# RHA - NOTES FROM THE FIELD

## CIVIL AND SITE COORDINATION

## HVAC COORDINATION

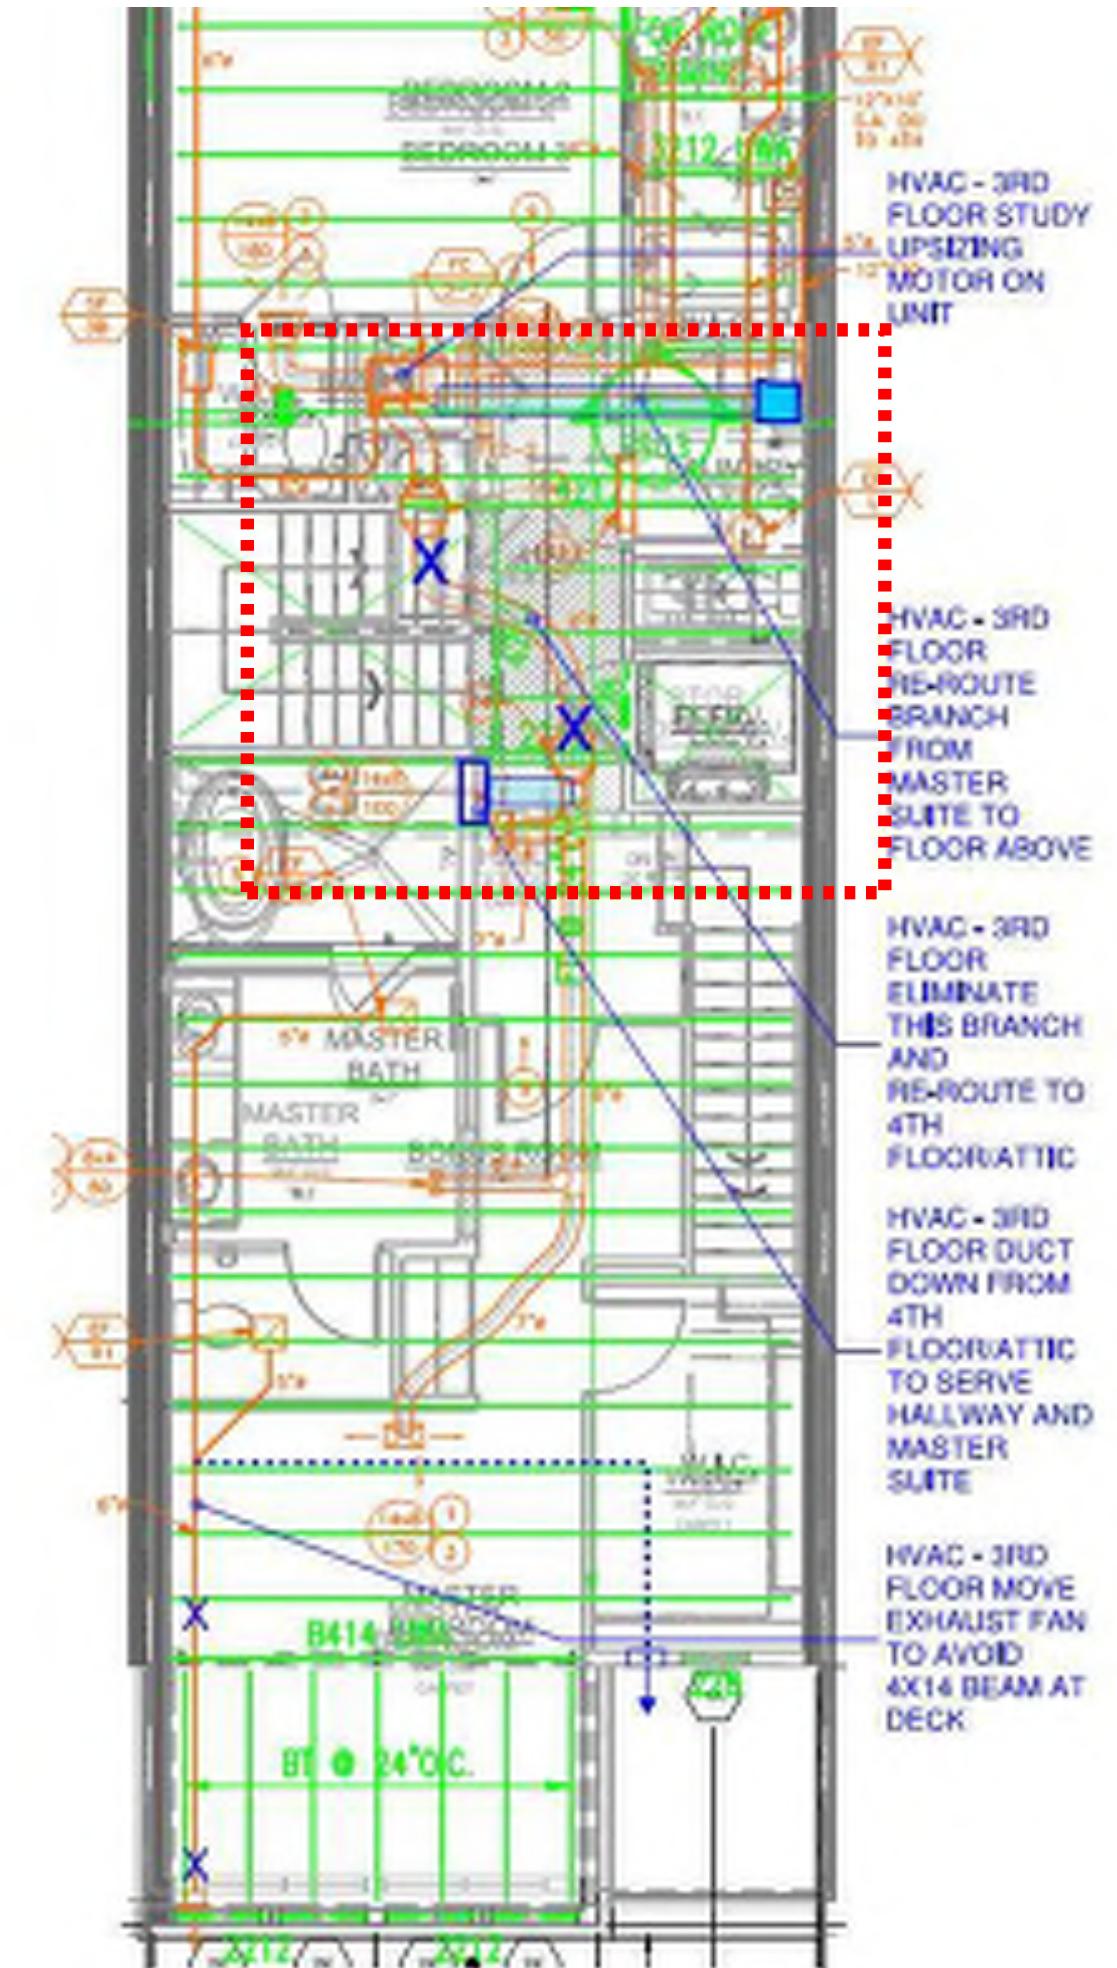
TAKE-AWAY: It is the architects responsibility to coordinate Mechanical and Structural Consultants. - Particularly when they are contracted under RHA

## ACCESSIBLE SHOWERS AND RESTROOMS

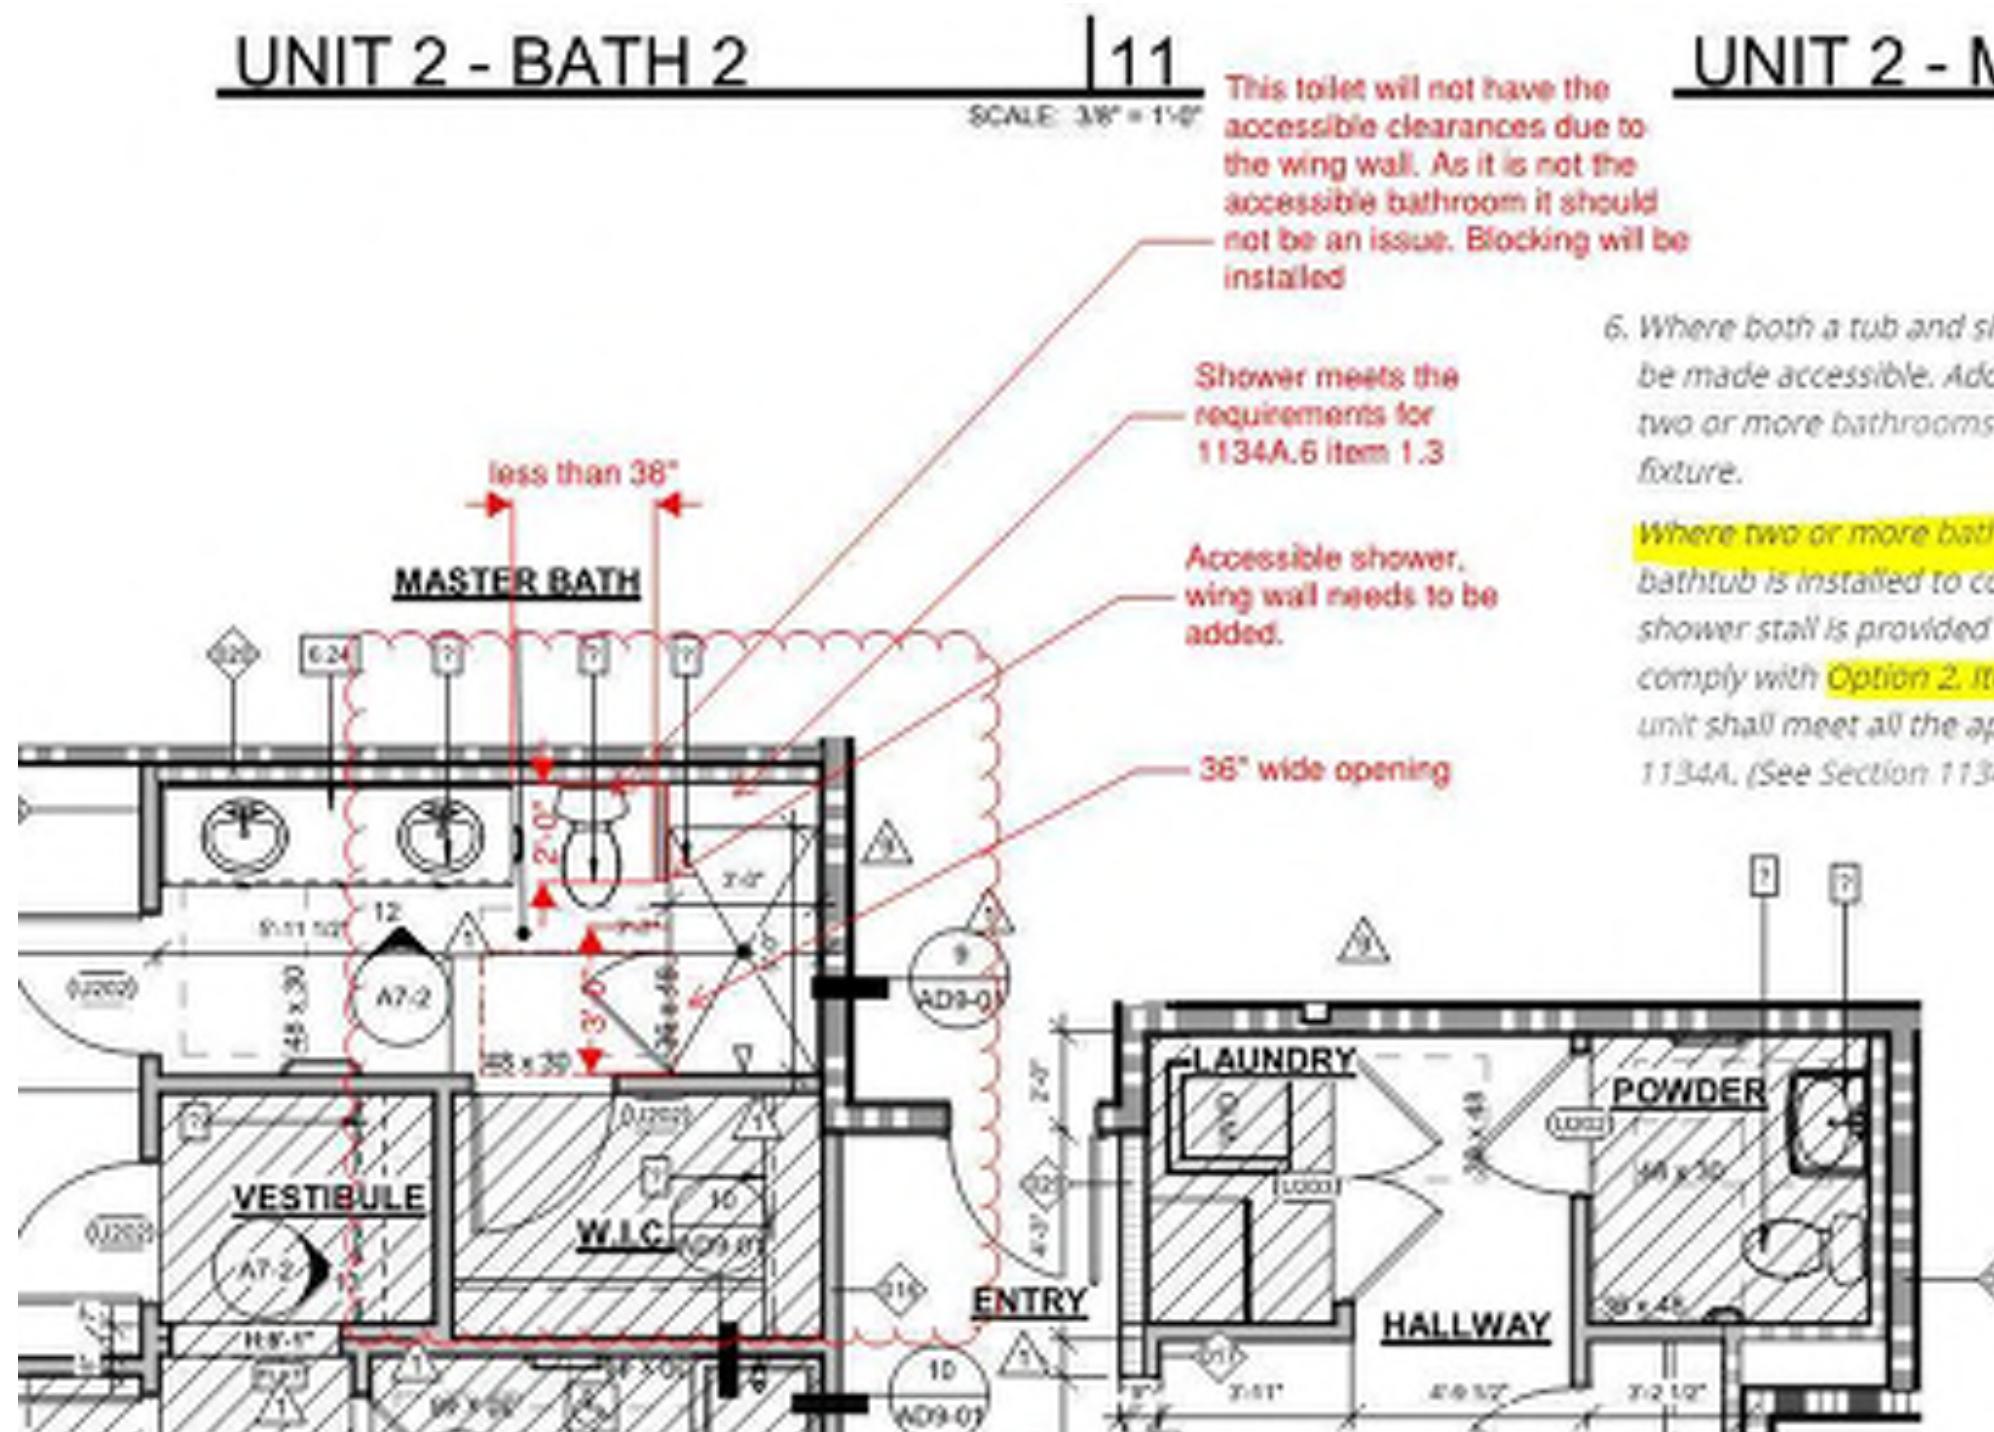
TAKE-AWAY: Coordinate requirements for designated accessible restrooms with tub/showers with Master Bathroom accessible roll-in showers.

## IN-FLOOR AUTO-OPERATORS AND FLOOR CLOSERS

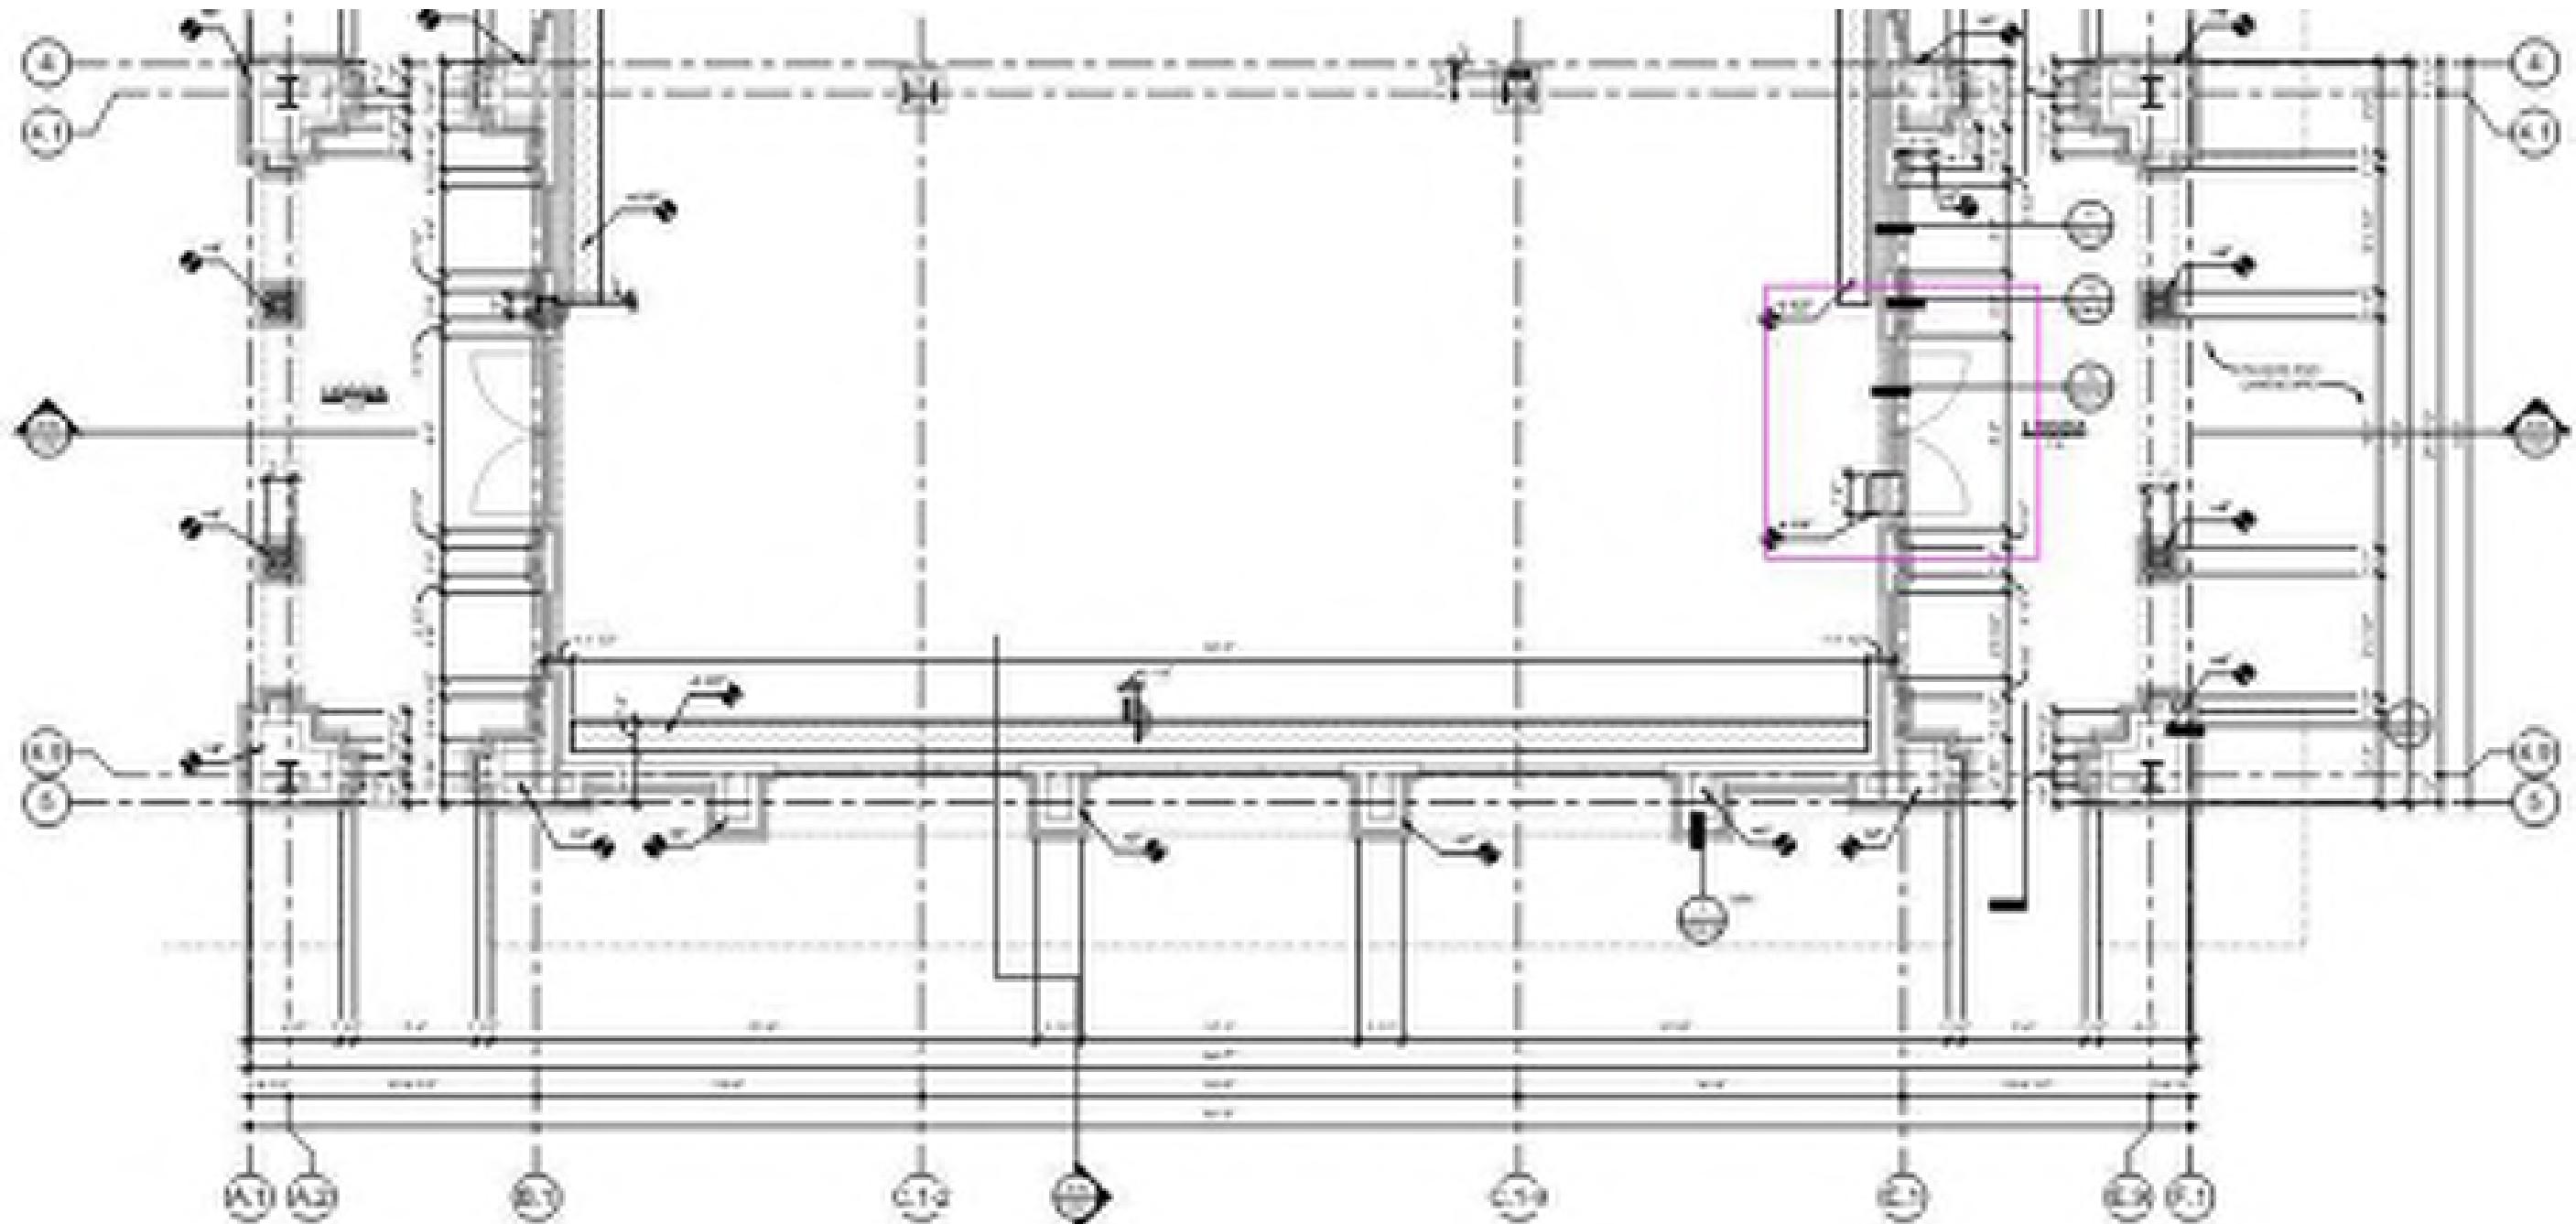
TAKE-AWAY: Coordinate all in floor hardware systems with Slab Plan (Auto-operator shown, however, floor closer boxes not shown on plan and were not held-out in concrete pour)

## SITE PLAN - PROJECT "DE-SCOPED"

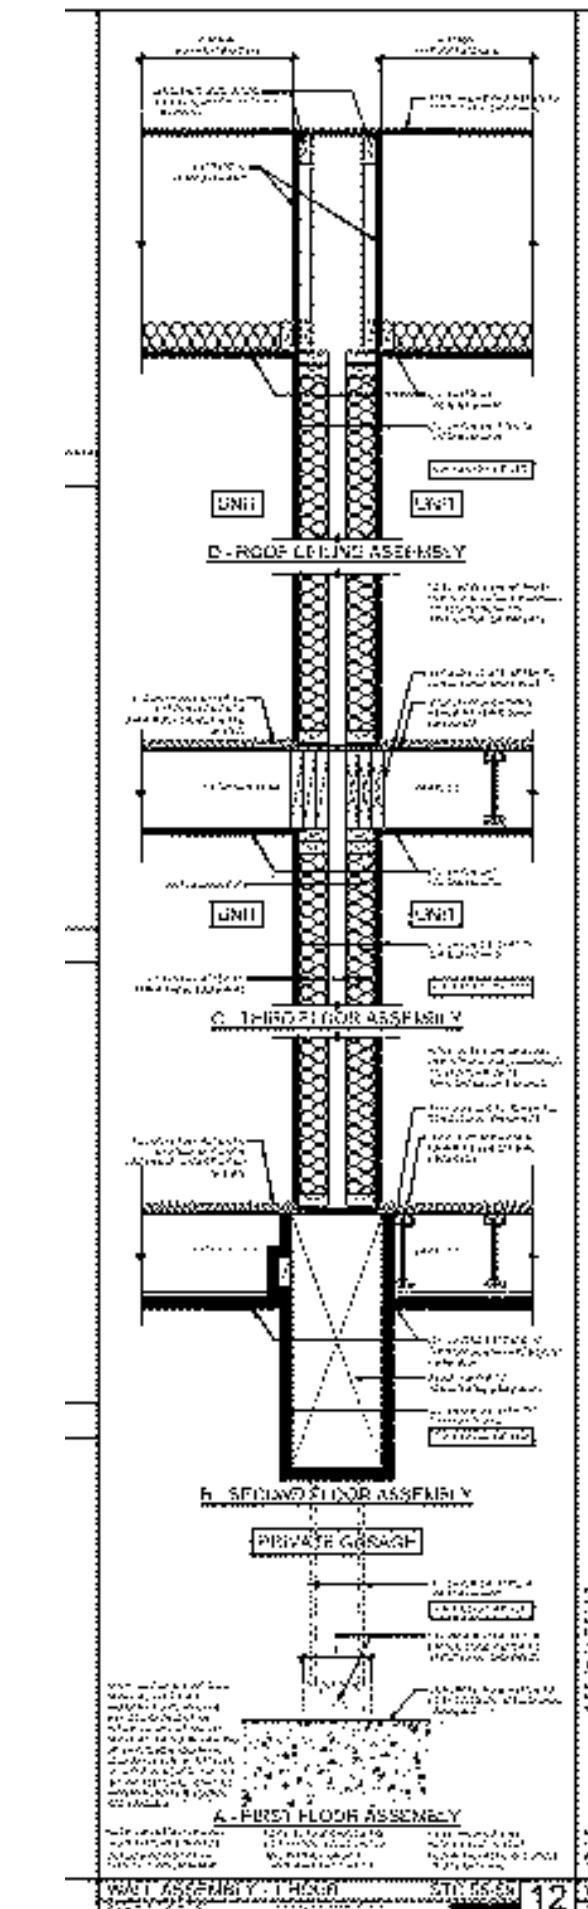
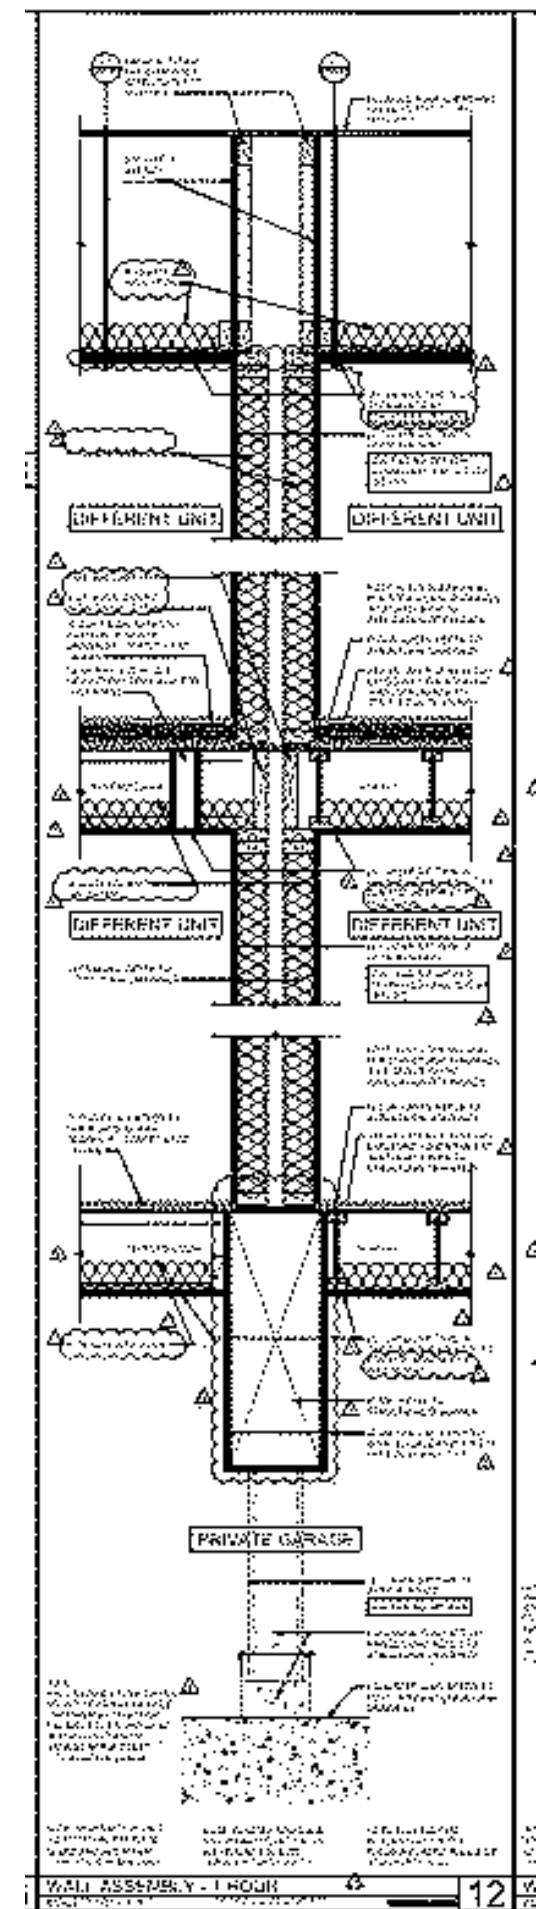
TAKE-AWAY: Client/Consultant Communication  
Understanding of Construction Type  
Sprinkler System Type, Distance between Buildings,  
Percentage of Openings and Fire-Resistive Assemblies

## ACCESSIBLE DOOR WIDTHS

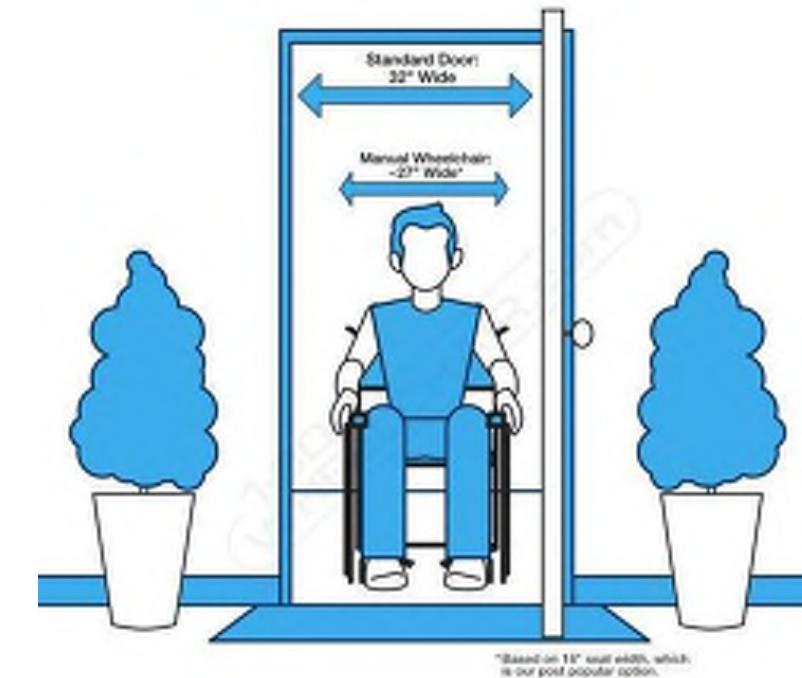
**TAKE-AWAY:** Provide 36" doors through-out on all multi-story elevated projects. A 34" door is no longer acceptable.
